# PBB-TE Requirements

## November, 2007

(intention is to submit these as comments for next .1Qay / .1AB-REV ballots)

# Do not restrict other types of PtMP SI

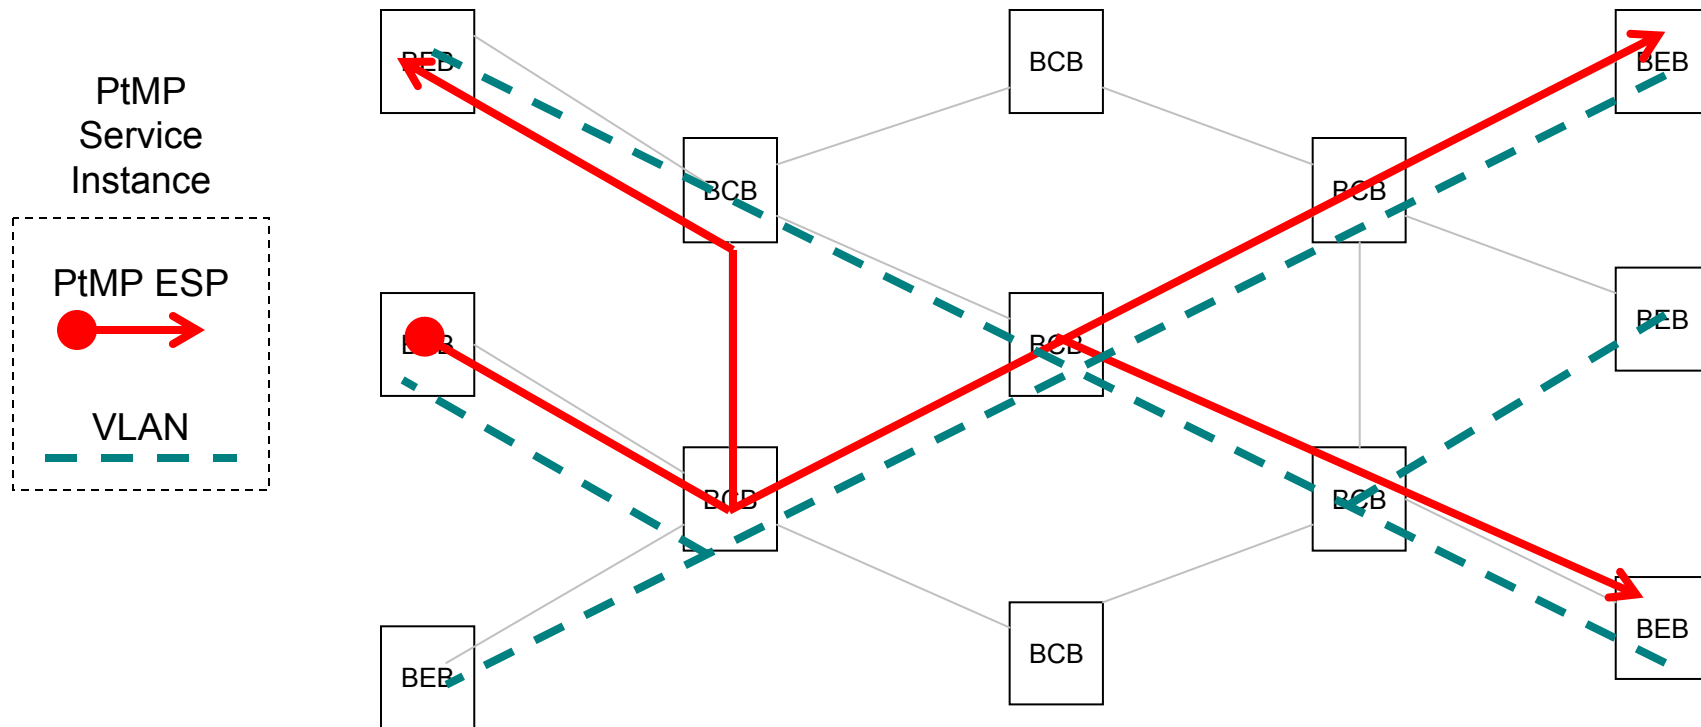
- E.g., P2MP ESP forward with VLAN (CL) return
- No problem to give this type a distinct name

# DCN similarly required for PBB-TE

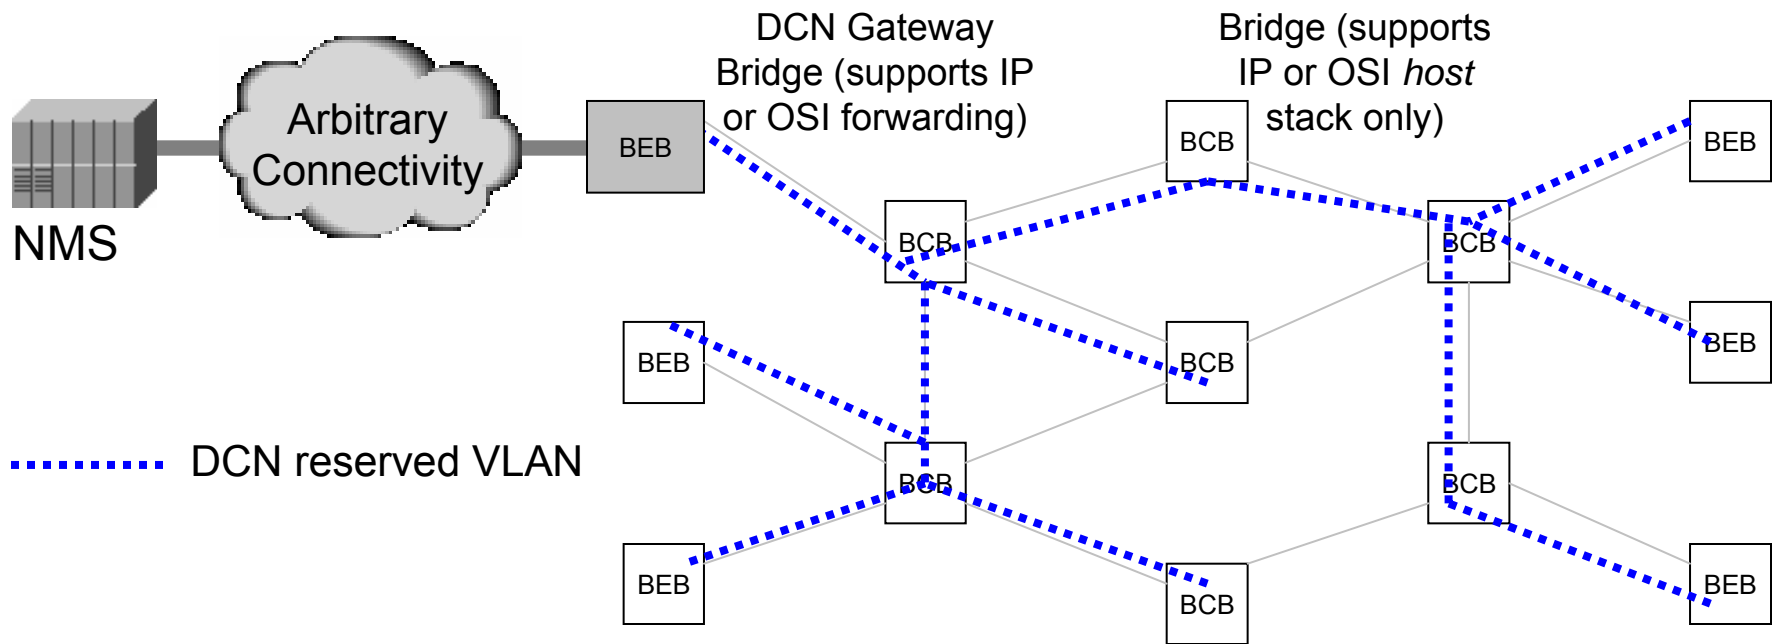
- DCN VLAN protocol *already* available in bridge
  - introduce reserved VID value
- No need for IP or OSI forwarding stack
  - except in GW Bridge(s)
  - but still need IP or OSI *host* stack in all bridges
  - or use IP or OSI forwarding at each Bridge (optional)

# Proposal

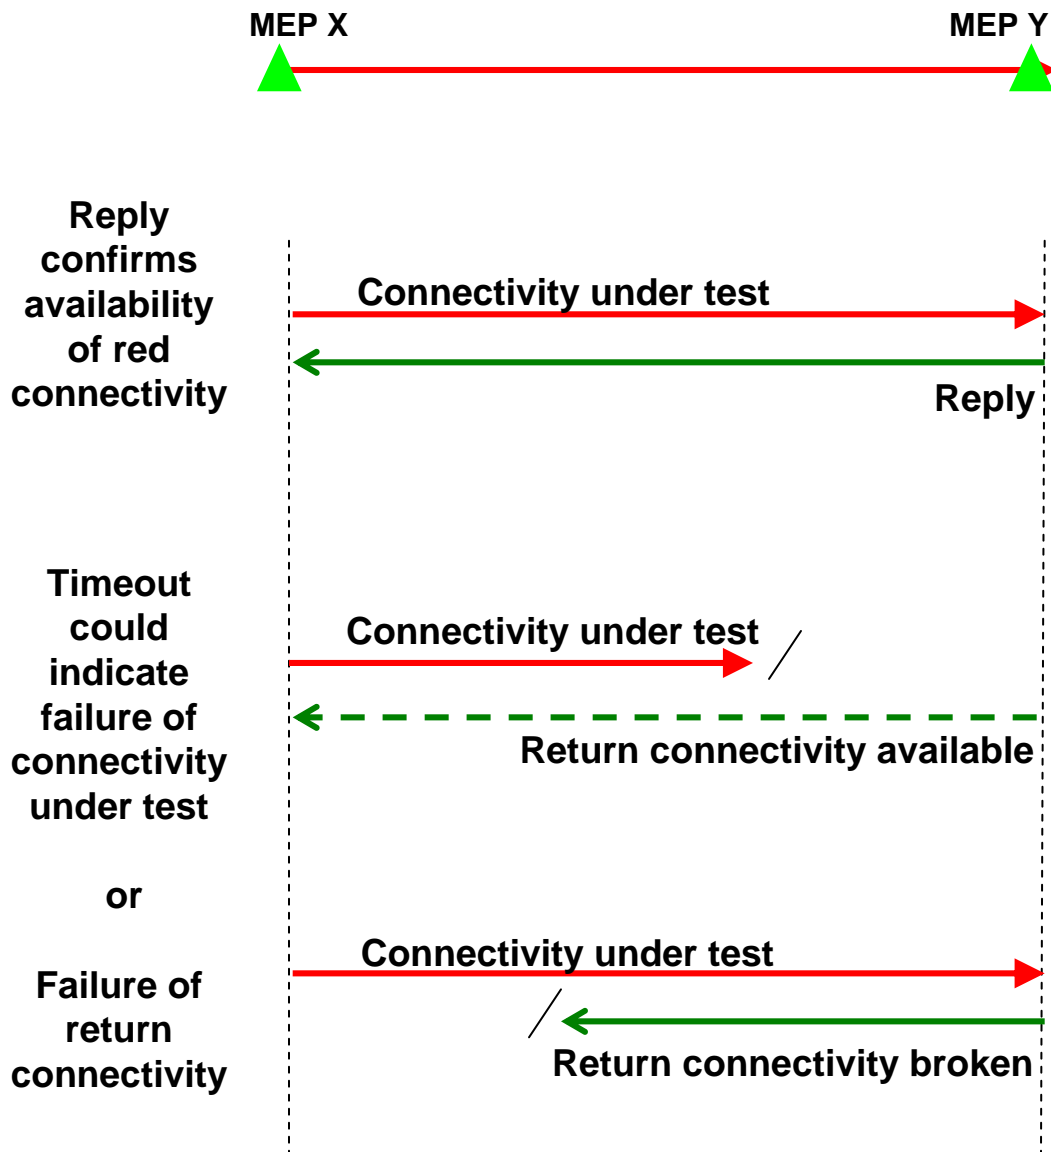
- Provision DCN-VID value on each bridge
  - Or use well-known value if agreement
- Detect inconsistencies in DCN-VID via LLDP
- Extend CFM to use DCN-VID (more on this)
- *CC required* on DCN VLAN

# Loopback does *not* test an individual ESP

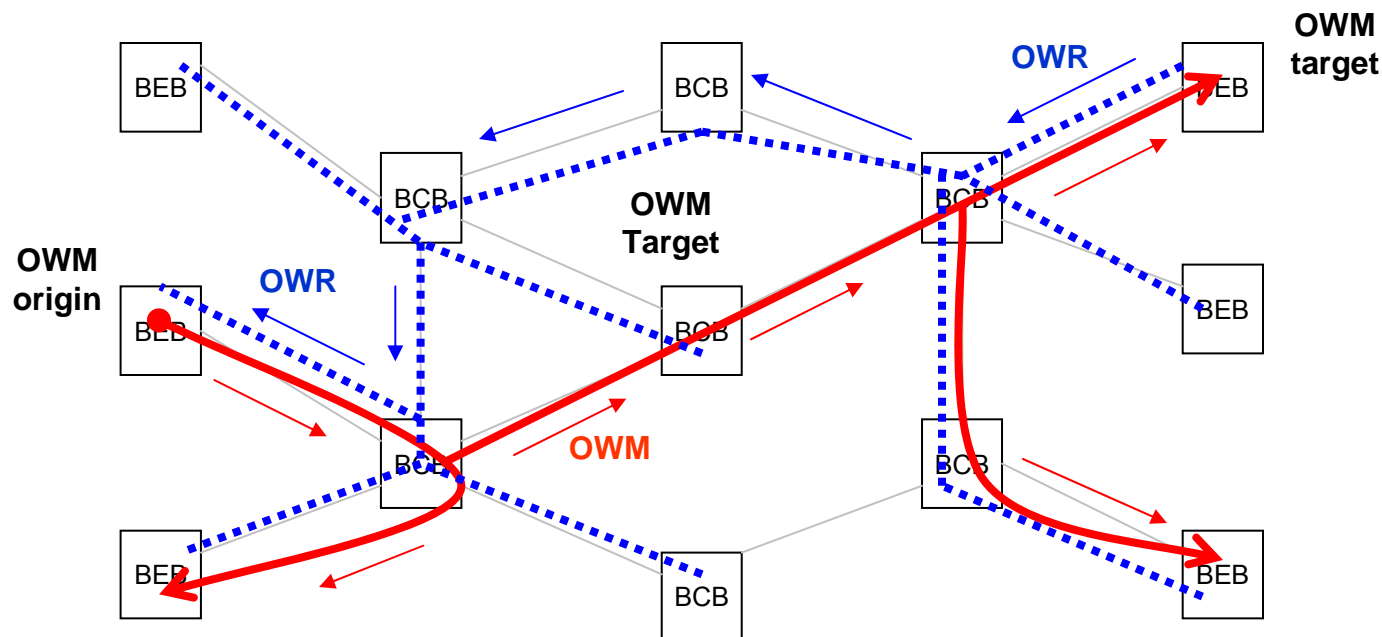
- Loopback tests the *combination* of forward and return connectivity
  - Not individual unidirectional ESP
- Cannot distinguish among the following cases:
  - The forward path is broken
  - The return path is broken
  - The forward and return paths are both broken
- The ‘one-way operation’ tests a *single* direction of connectivity and tells you whether:
  - The one-way connectivity is intact
  - The one-way connectivity has failed
  - The result cannot be determined because the return connectivity (e.g., DCN path) has failed
- Eliminates dependence on state of a second path

- Add CFM operation to test one-way connectivity to specific target on ESP
- OWM similar in format to PBB-TE LBM
- OWR sent on DCN whose integrity is guaranteed by CC (within limits of CC interval)
  - Option to issue Loopback operation on DCN if long CC interval is a concern.
